Adaptable & Livable Apartments

| CURRENT REVISION COMMENTS | | |
|--|-------------------------|----------|
| 5 | Development Application | 13.07.18 |

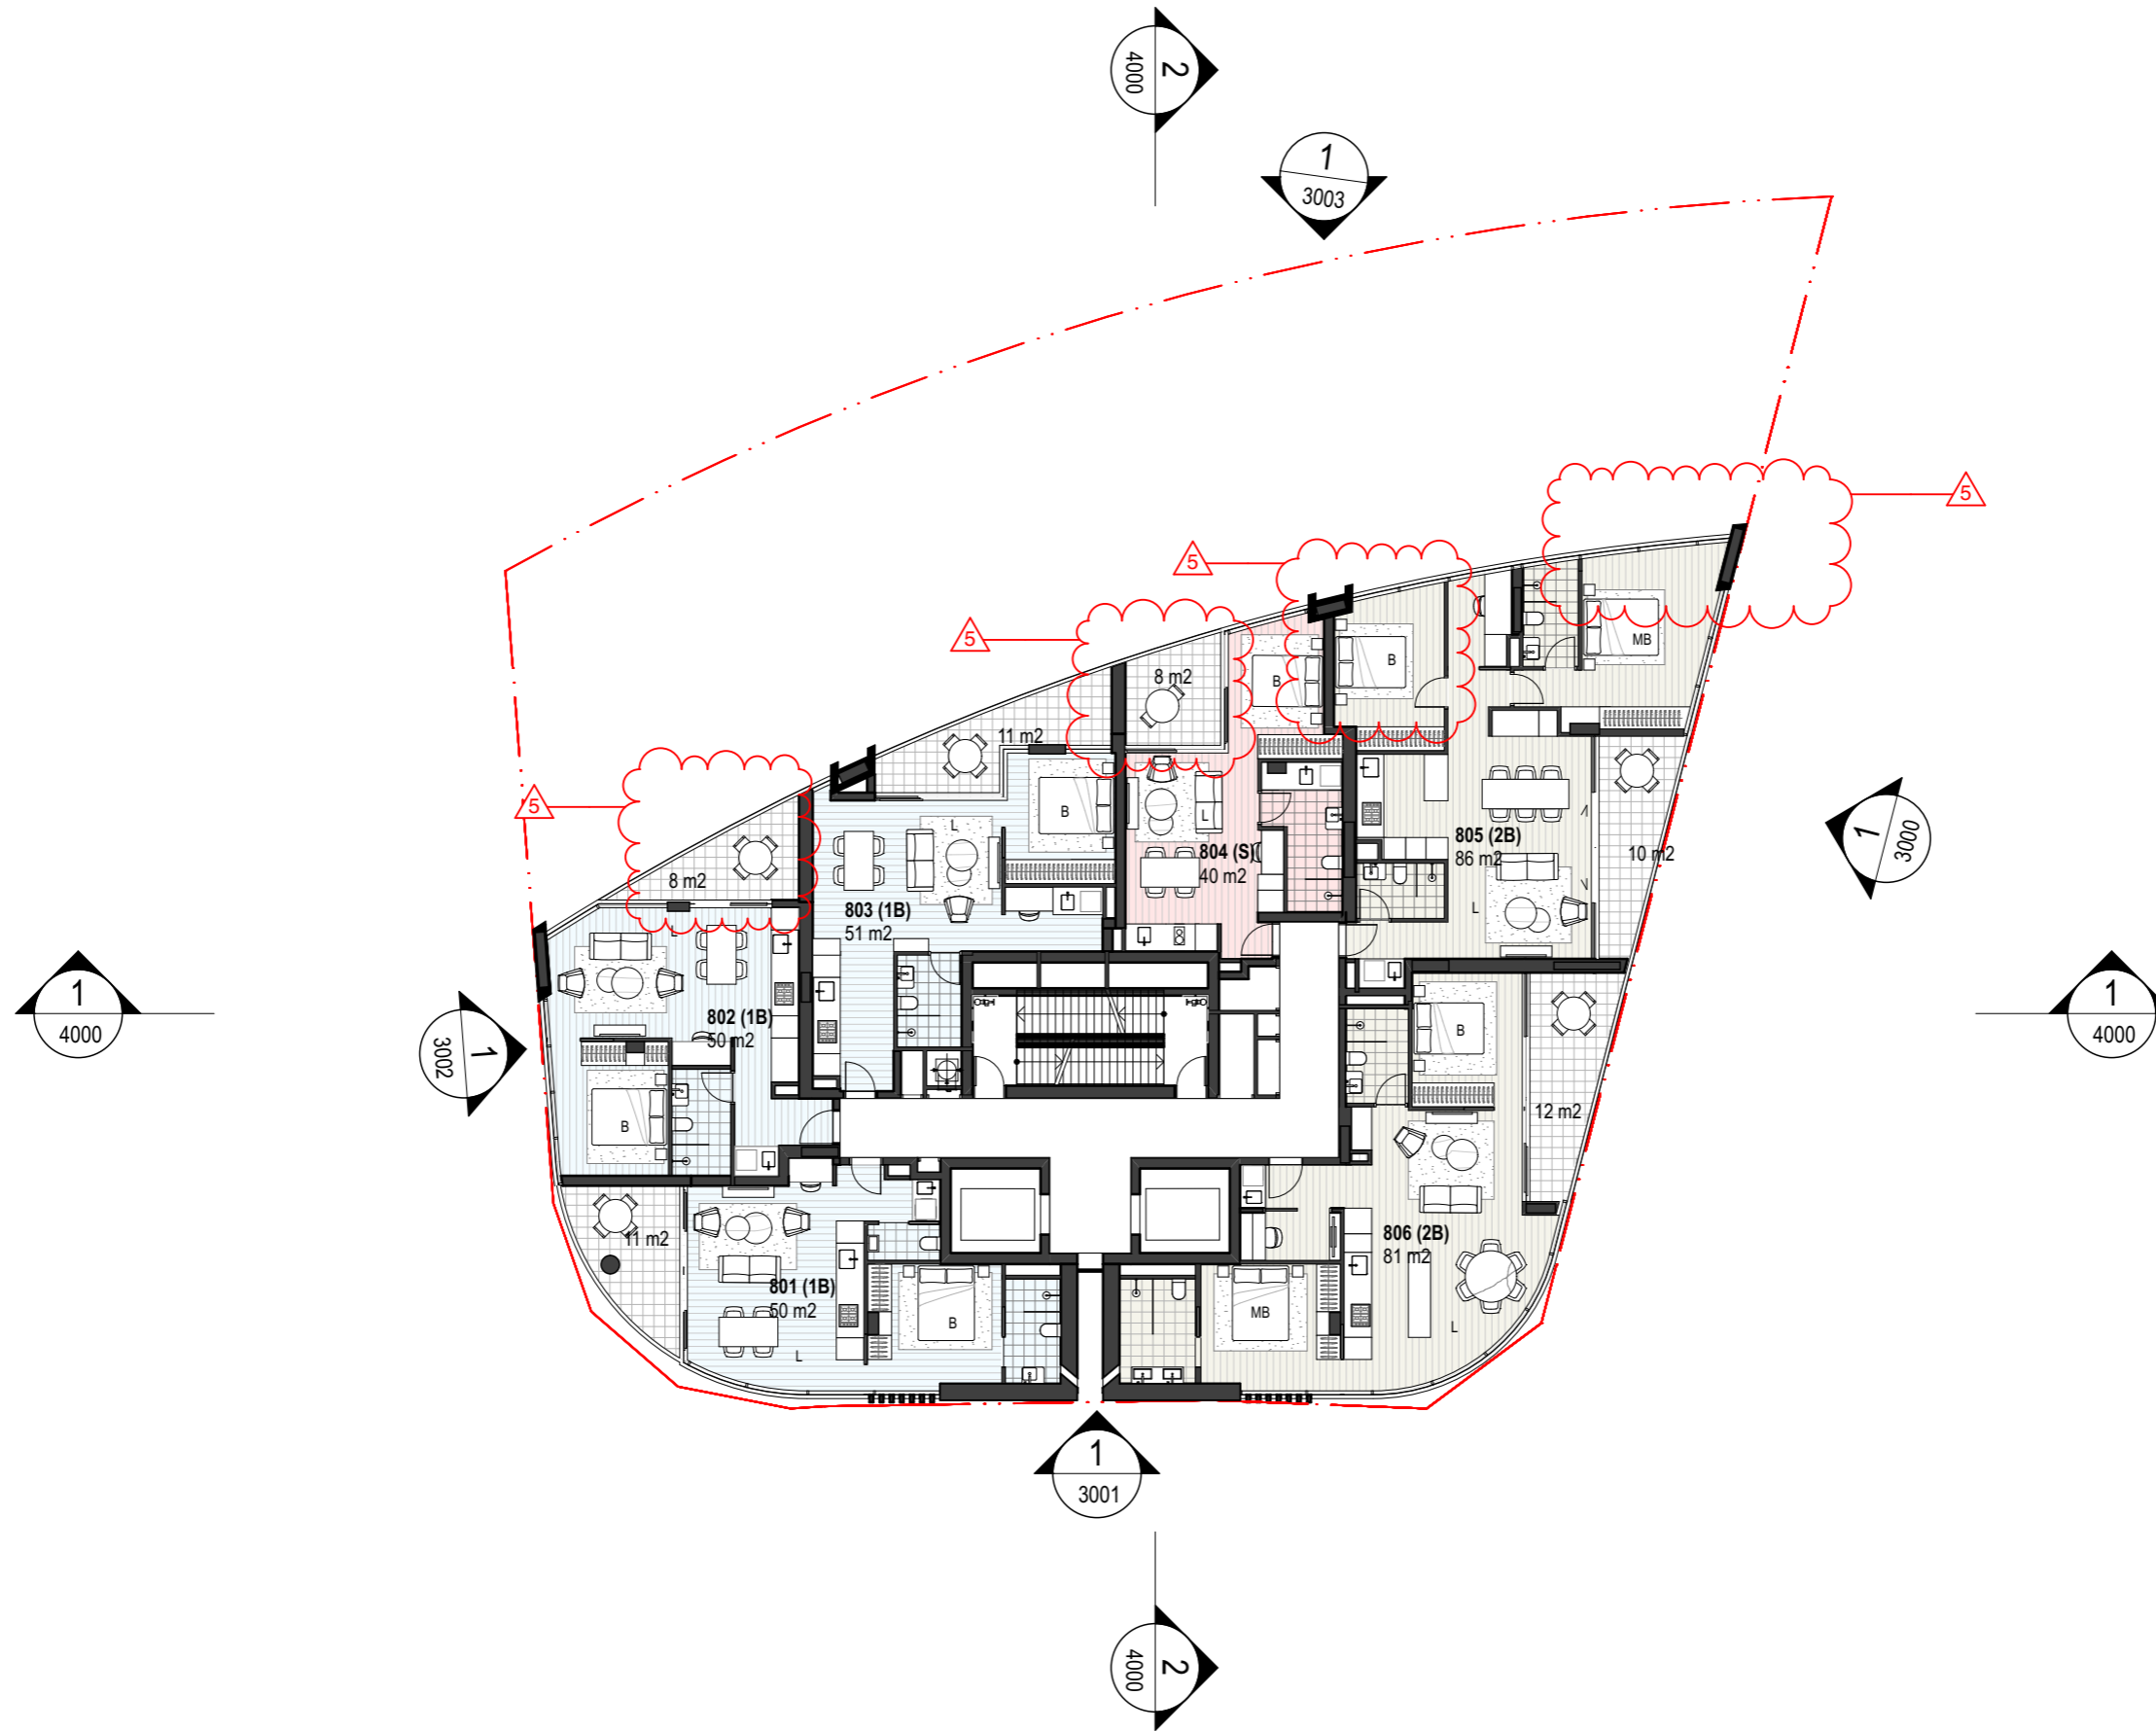
| CURRENT REVISION COMMENTS | | |
|--|-------------------------|----------|
| 1. UNIT 505 MODIFIED TO ACCOMODATE 3x3m IN ALL BEDROOMS. | | |
| 2. BALCONIES UNITS 502 AND 503 MODIFIED TO ACHIEVE 1m DEPTH FOR BALCONY COUNTED AREA | | |

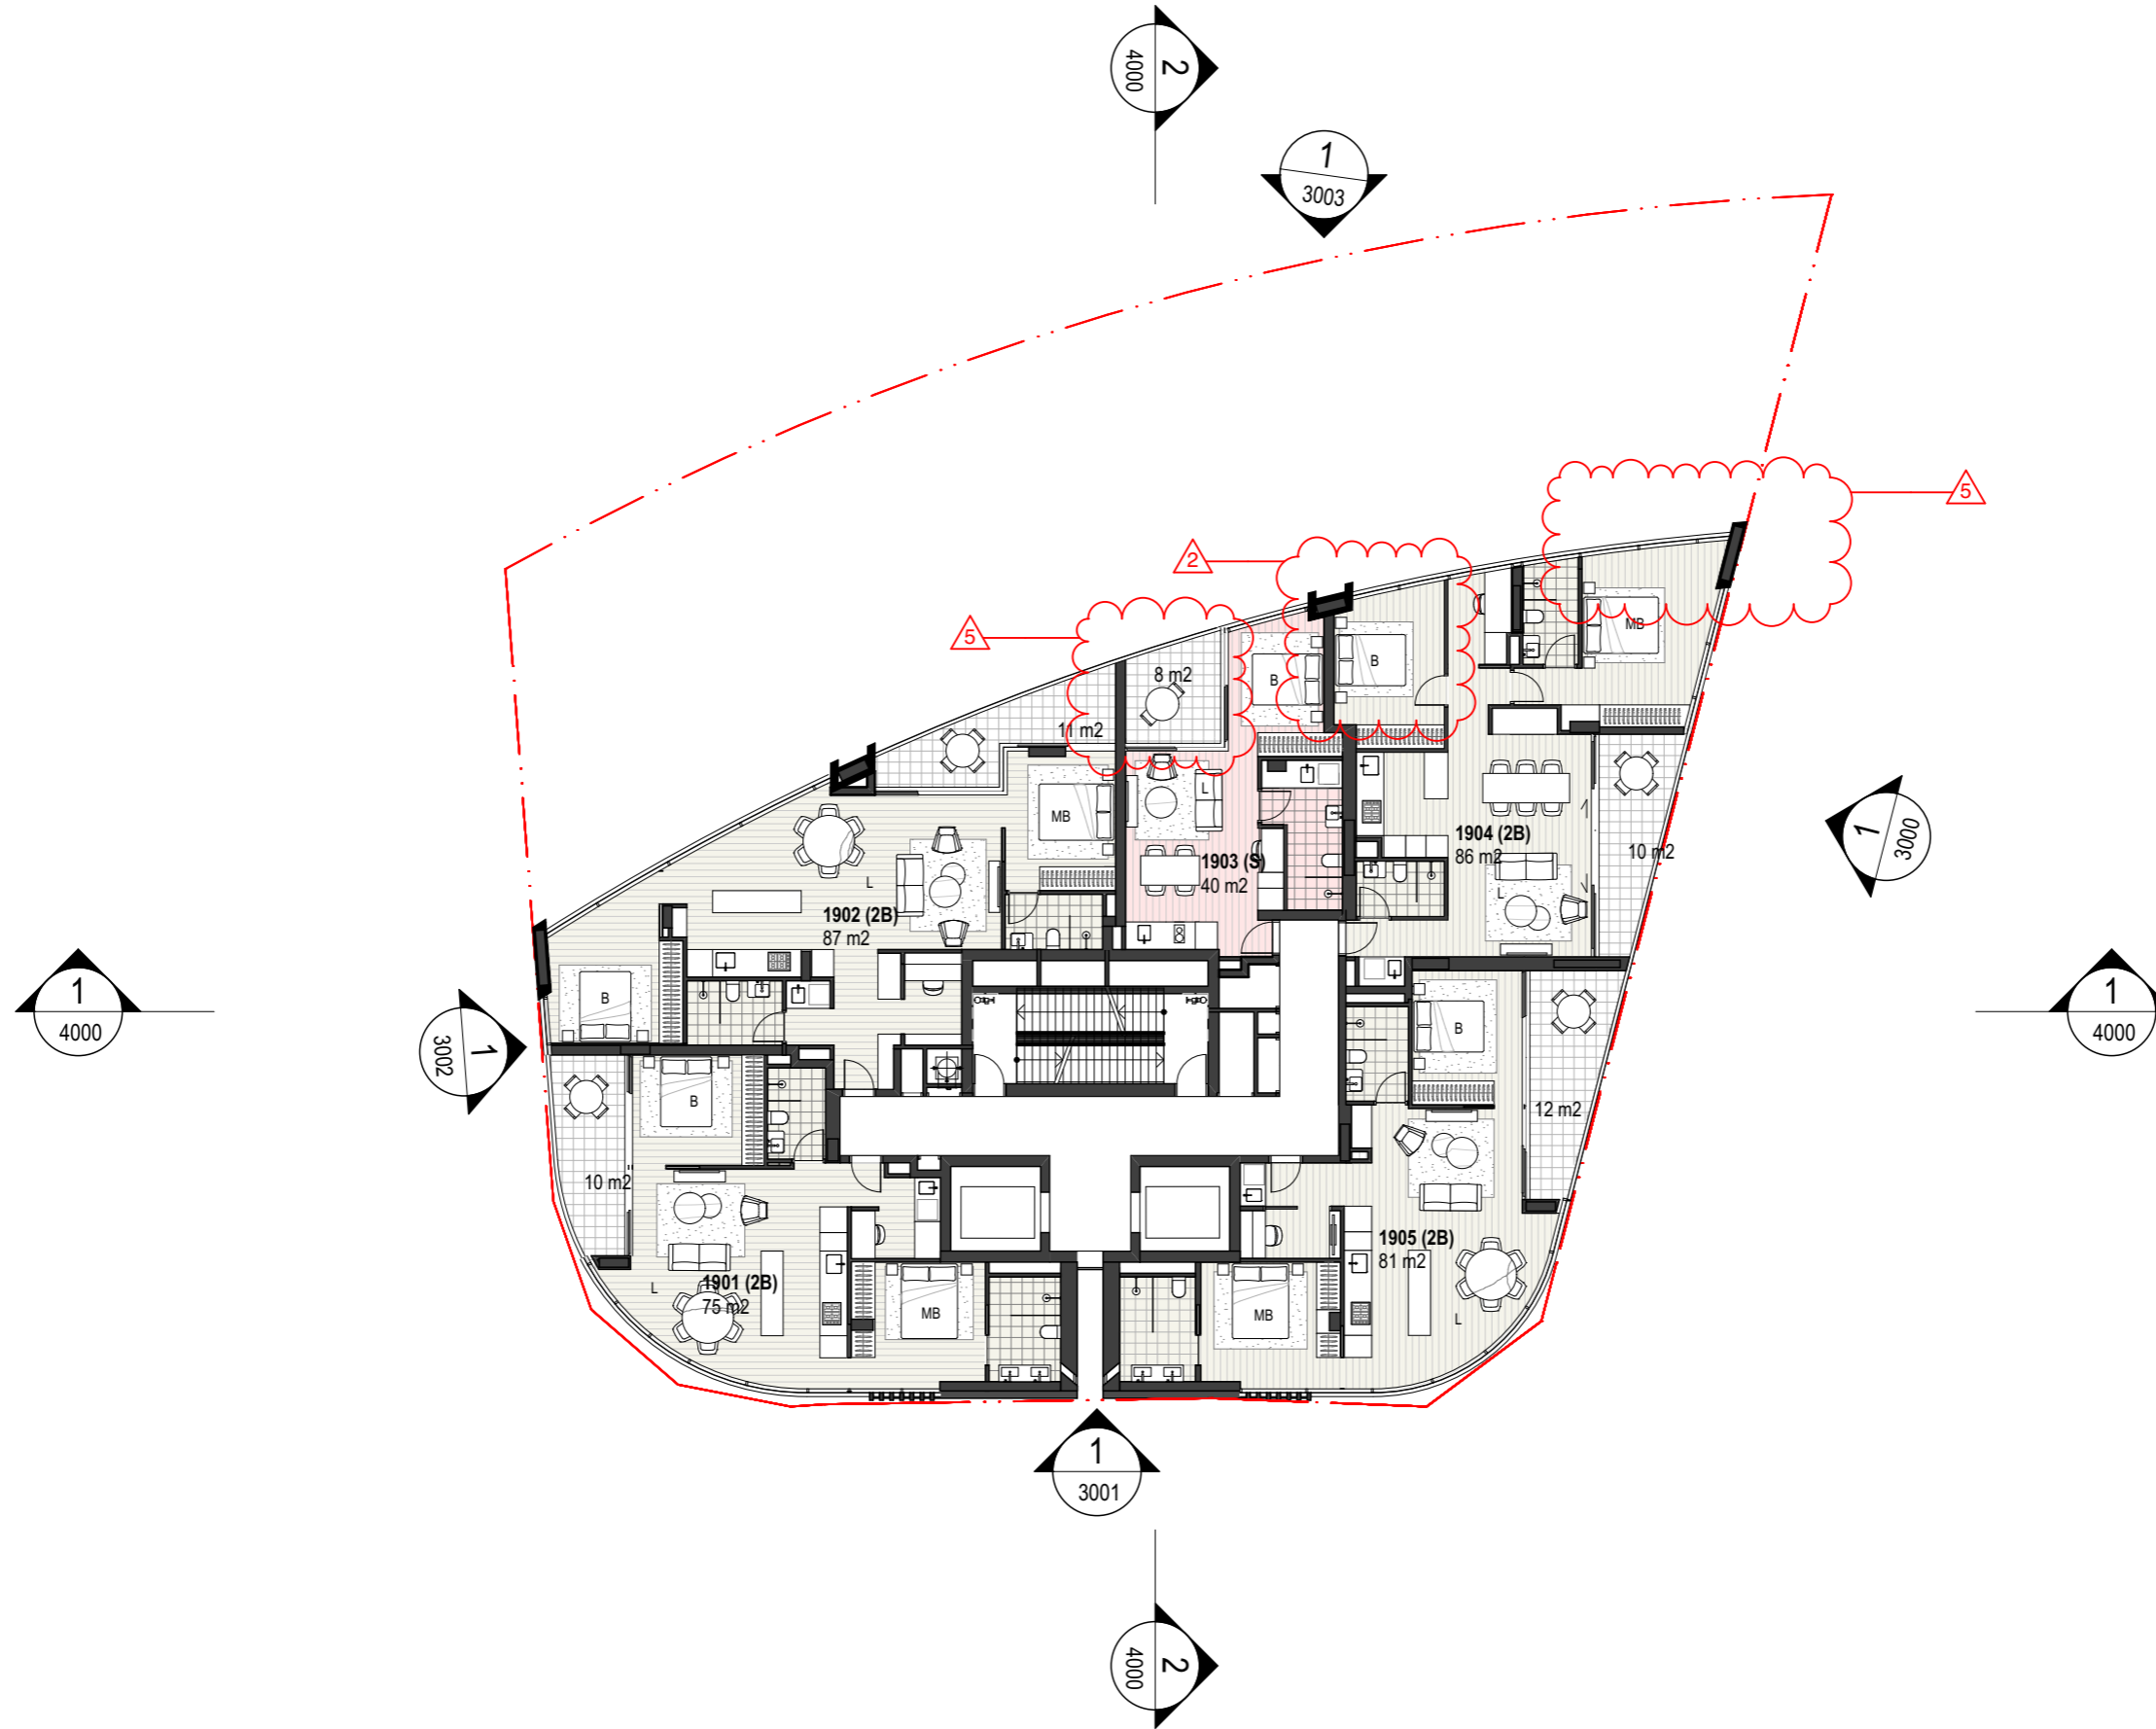
| CURRENT REVISION COMMENTS | | |
|--|-------------------------|----------|
| 1. UNIT 805 MODIFIED TO ACCOMODATE 3x3m IN ALL BEDROOMS. | | |
| 2. BALCONY UNIT 802 MODIFIED TO ACHIEVE 1m DEPTH FOR BALCONY COUNTED AREA. | | |
| 3. ADDITIONAL BALCONY IN UNIT 805 DELETED. | | |
| 4. BALCONY UNIT 804 INCREASED. | | |

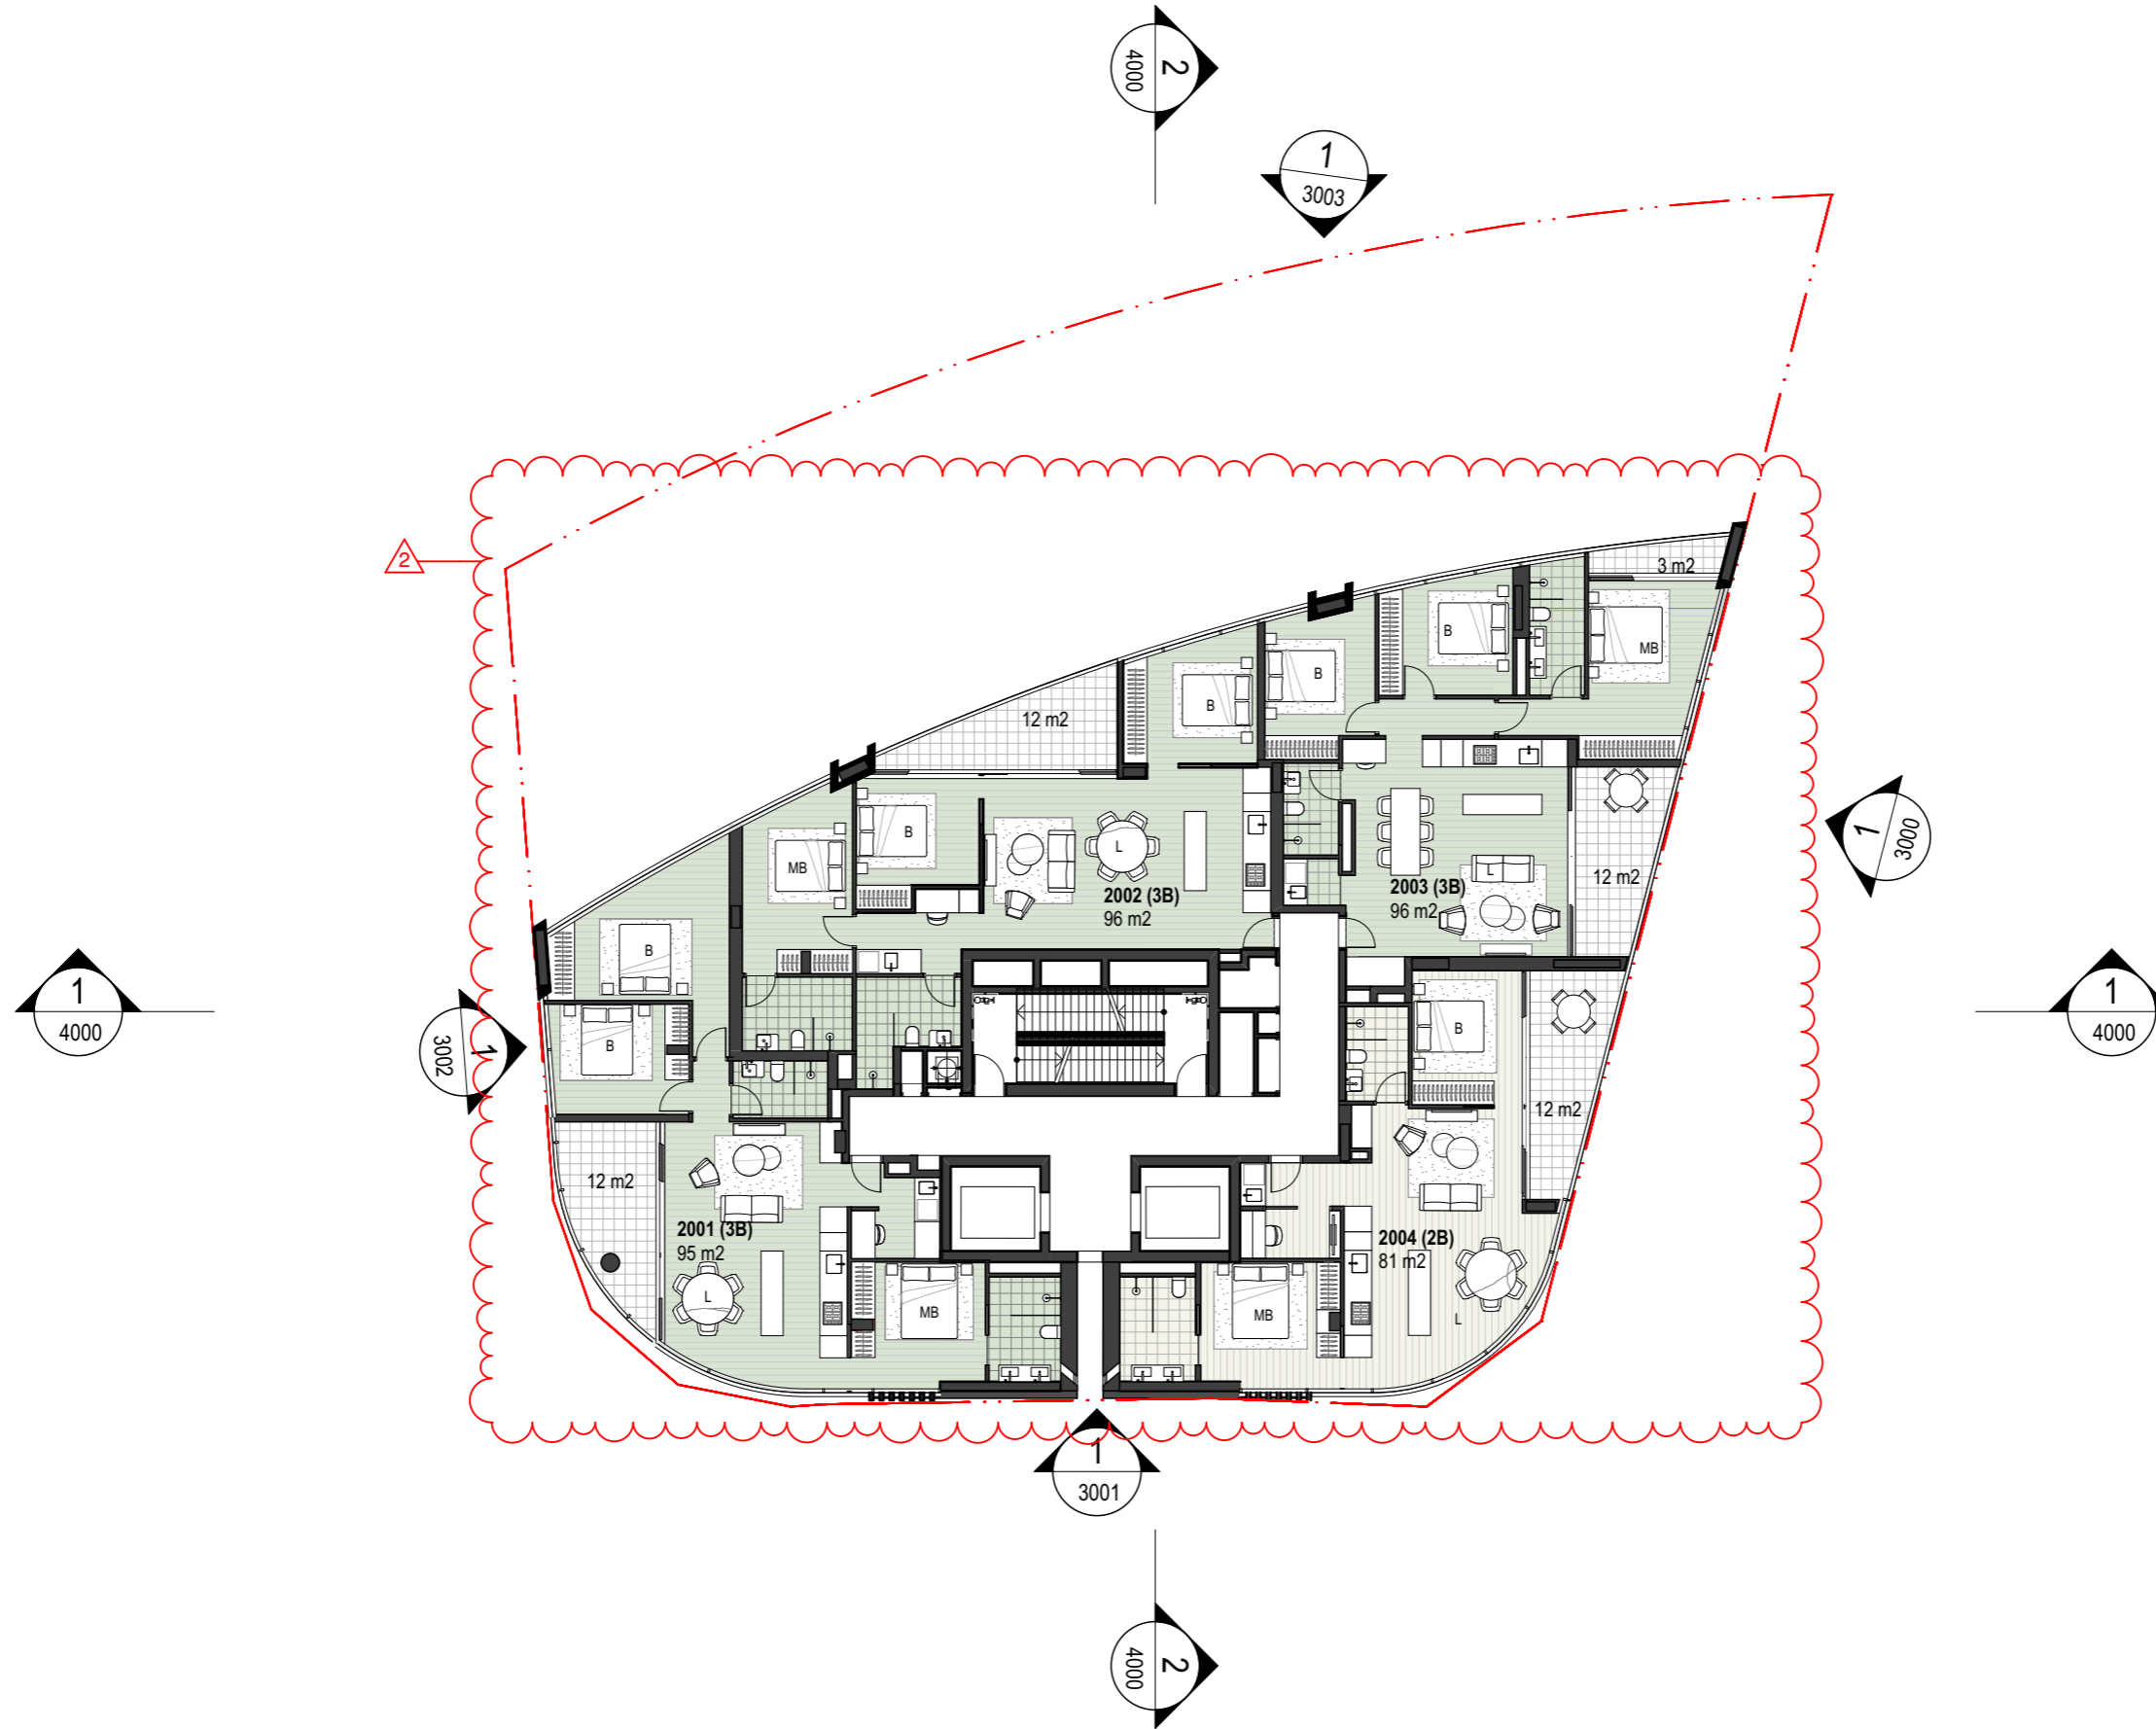
| CURRENT REVISION COMMENTS | | |
|---|-------------------------|----------|
| 1. UNIT 1904 MODIFIED TO ACCOMODATE 3x3m IN ALL BEDROOMS. | | |
| 2. ADDITIONAL BALCONY IN UNIT 1904 DELETED. | | |
| 3. BALCONY UNIT 1903 INCREASED. | | |
